## **REVISED STAFF REPORT AND RECOMMENDATION TO THE DESIGN COMMISSION**

CASE FILE: LU 19-145295 DZM  
EA 18-181375 APPT, PC 18-202411, EA 18-210300 DA  
**Hyatt Place**

The applicant is seeking **Design Review** approval for a 23-story mixed use building, which includes hotel and residential uses, in the Pearl Sub-District of the Central City Plan District. The proposed height of the quarter-block building is 250' with 197,118 square feet of floor area. 170 hotel rooms and 110 dwelling units are proposed. No on-site

# HYATT PLACE | TYPE III DESIGN REVIEW | ELEVATIONS - WEST

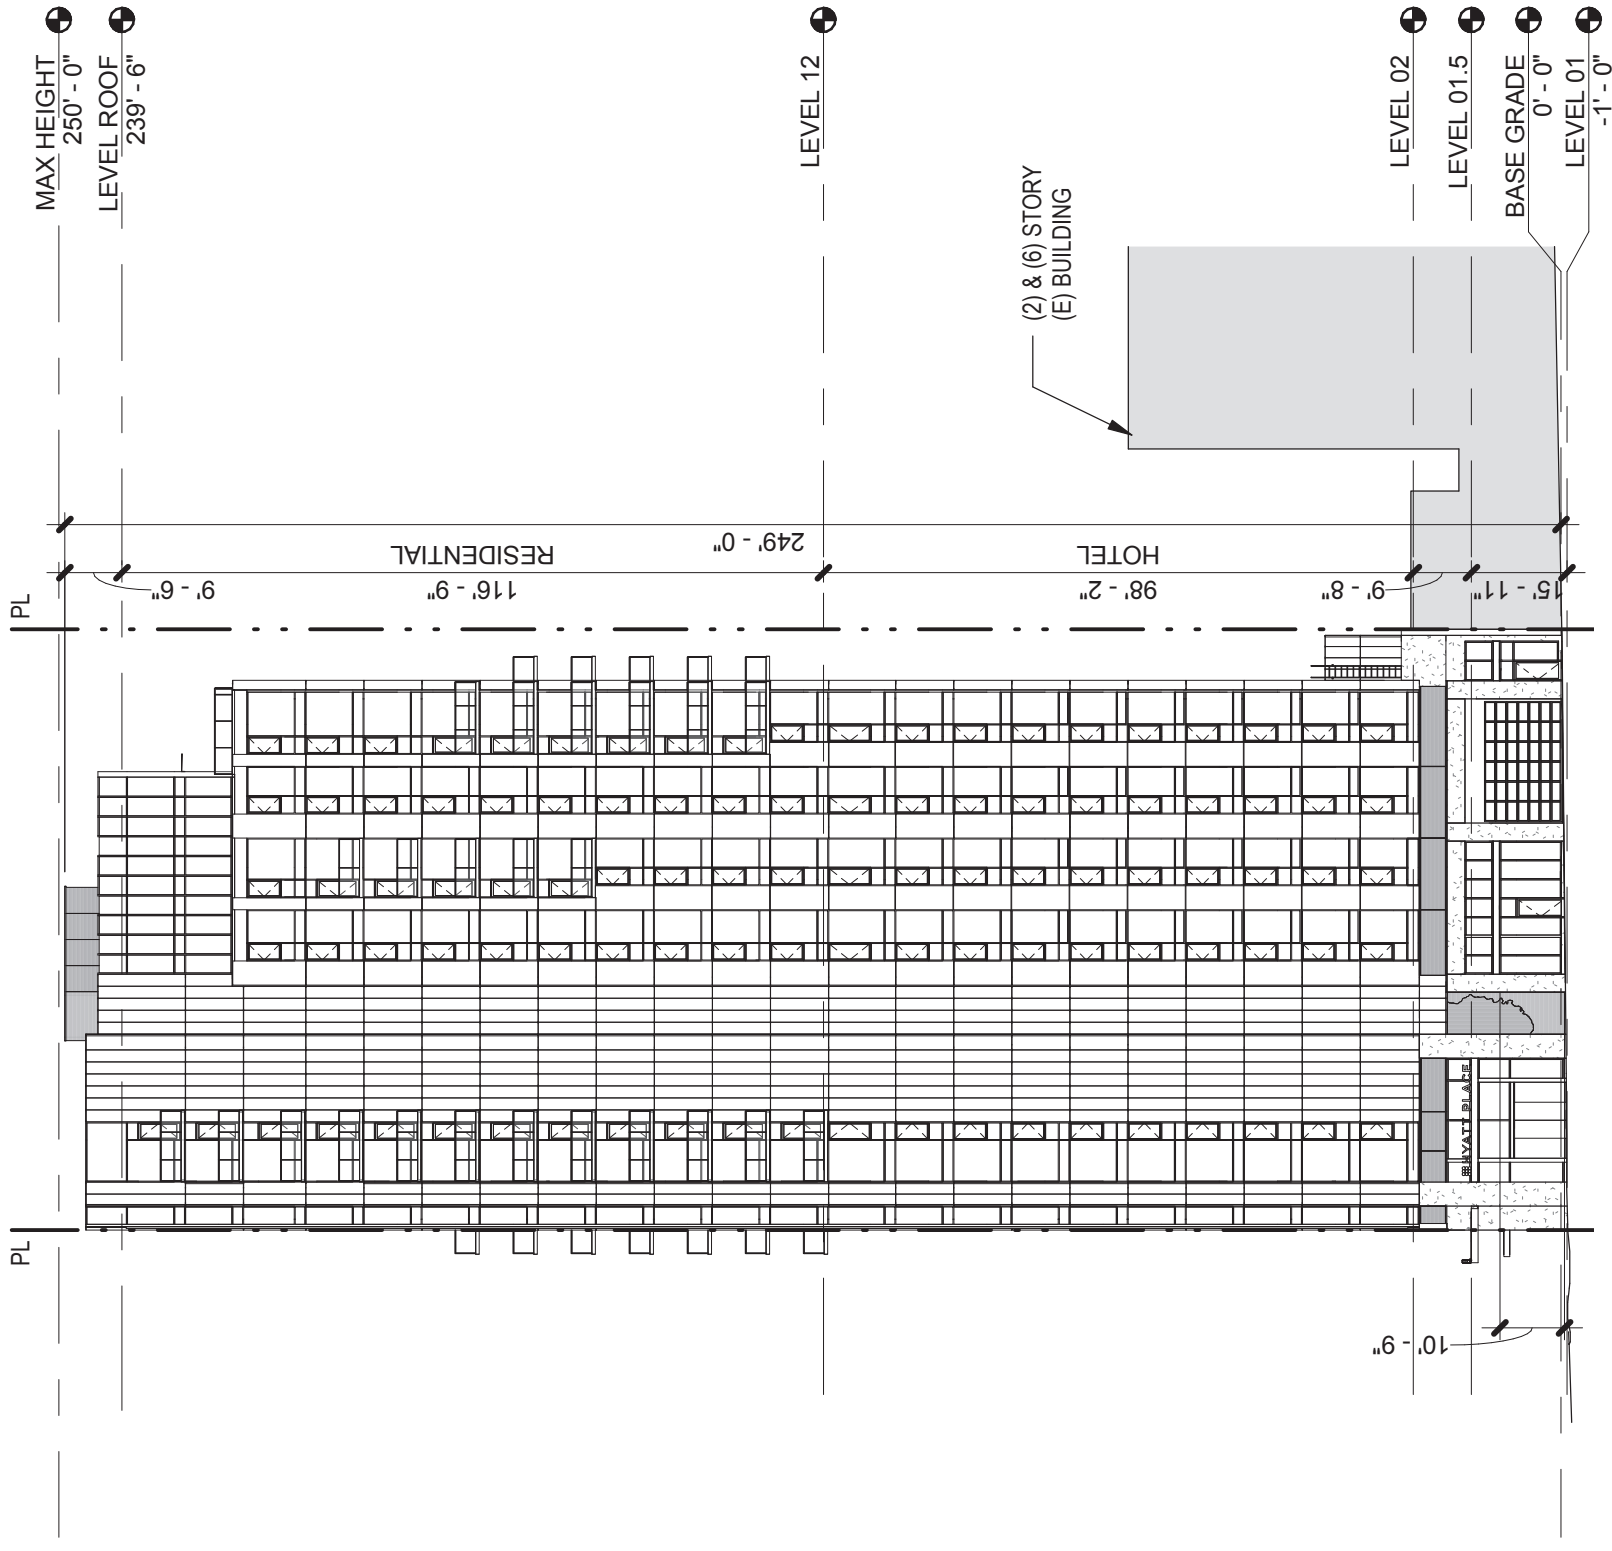
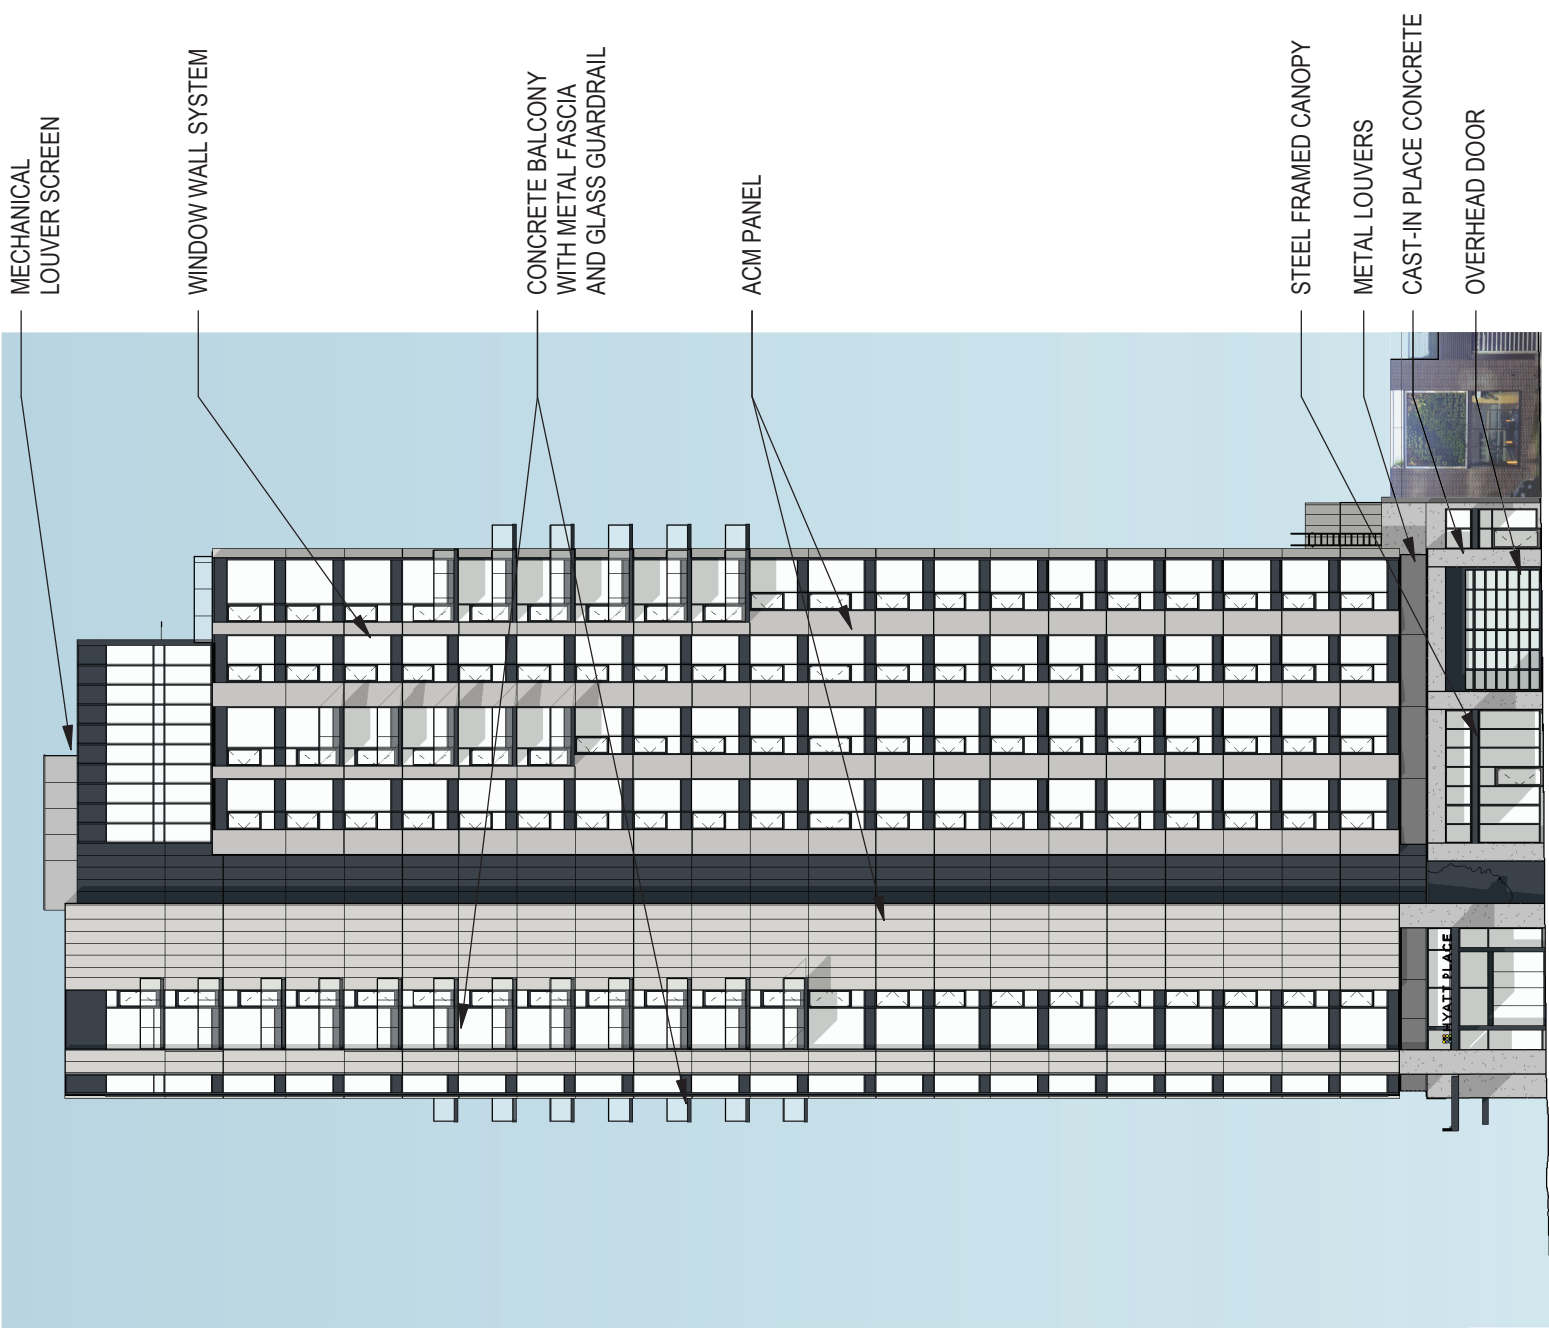
**Findings for A2, A5-3 and A5-4:** A water feature is proposed on the west elevation of the building to be located within the recess between the west elevation hotel entrance and the residential entrance. The proposed cascading water feature is approximately 7 feet wide and 20 feet in height. It is intended to be an art piece that evokes connections to Portland's tradition of fountains and water features while also providing a historic nod to Tanner Creek.

The proposed water feature, which is intending to meet three guidelines, is located at the base of a vertical expanse of metal panel running the entire height of the building's west elevation. While this may be an appropriate (and eventually successful) location for the feature, the current design and unresolved base to the tower is not yet fully developed in that it is neither integrated with the building nor "celebrating the building access points", as is stated in the Guideline A2.

*Therefore, this guideline is not fully met.*
